**Karuah South Quarry**

## Ecological review of the proposed Karuah South Quarry Project SSD 8795

## Internal Referral Advice

Figure 4.1 APPROXIMATE MINIMUM EXTENT OF THE LOCAL POPULATION OF ASPERULA ASTHENES

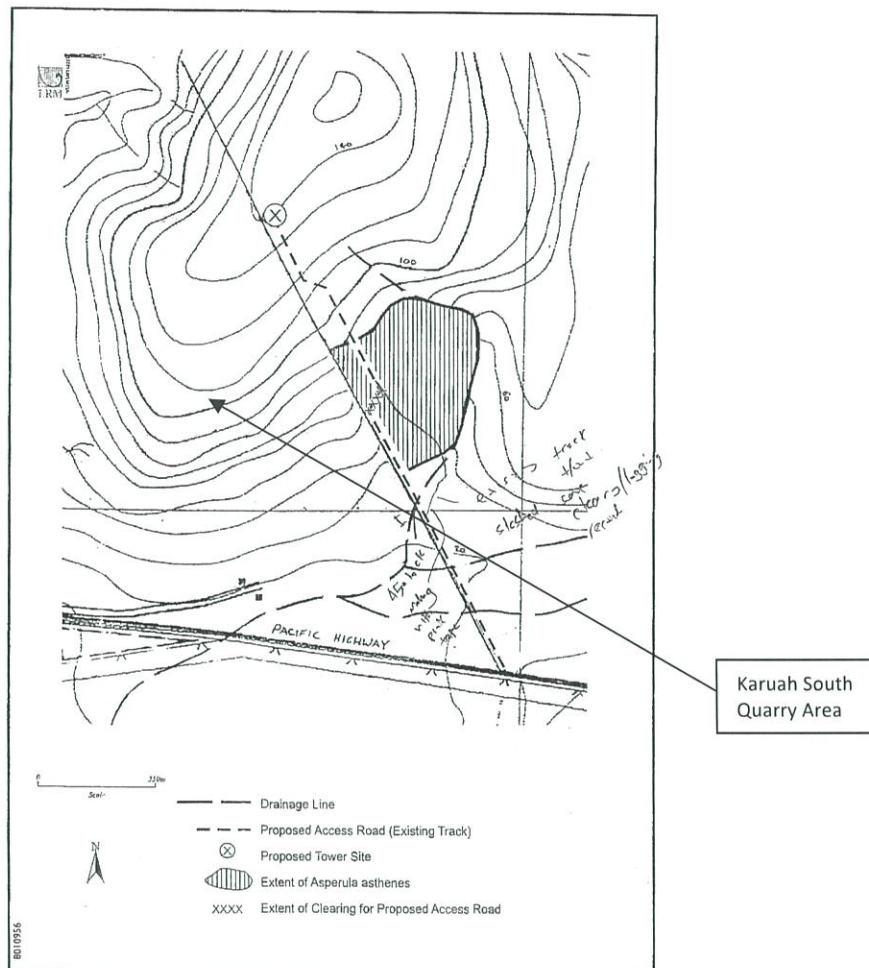
For instance, *Asperula asthenes* was not detected during the BDAR field surveys. It is however known and described on the adjacent Lot 12, where ERM 2002 said “an extensive population of this species was detected in the moist open forest habitat... The minimum extent of the local population is approximately 4.5-hectares... This local population is likely to extend into adjacent moist open forest habitat south-west of the study area, which could not be inspected during the current survey due to site access constraints.” The habitat so described sits on the subject land for this quarry proposal and so there is evidence that *Asperula asthenes* was present on that land. The plan from ERM 2002 is provided below.

Population of *Asperula asthenes* adjacent to the Karuah South Quarry proposal (from RPS 2013)

To my knowledge, this area comprises the known south-eastern limit of *Asperula asthenes* distribution and thus is of special significance.
